**Proposed Code Case and Code change to ASME Section XI, Appendix VIII, Supplement 11**

**SUPPLEMENT 11 — QUALIFICATION  
REQUIREMENTS FOR FULL STRUCTURAL  
OVERLAID WROUGHT AUSTENITIC  
PIPING WELDS**

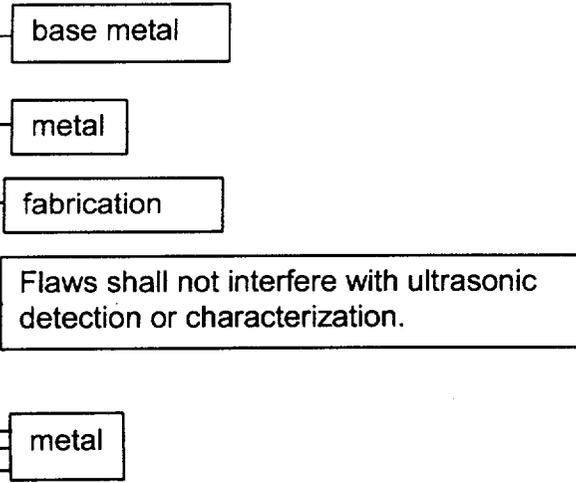
The major difficulty with the current Supplement 11 is that it requires that all flaws be cracks. As illustrated below implanting a crack requires excavation of the base material on at least one side of the flaw. While this may be satisfactory for ferritic materials, it does not produce a useable axial flaw in austenitic materials because the sound beam, which normally passes only through base material, must now travel through weld material on at least one side. For this reason paragraph 1.1(d)(1) was modified to allow for the use of alternative flaw mechanisms under defined conditions.

(a) A minimum of 70 percent of the flaws in the detection and sizing tests shall be cracks. Alternative flaw mechanisms, if used, must provide crack like reflective characteristics and be limited by the following:

(1) Alternative flaws must be limited to the case where implantation of cracks precludes obtaining a realistic ultrasonic response.

(2) Alternative flaws must be semielliptical with a tip width of less than or equal to 0.006 inches.
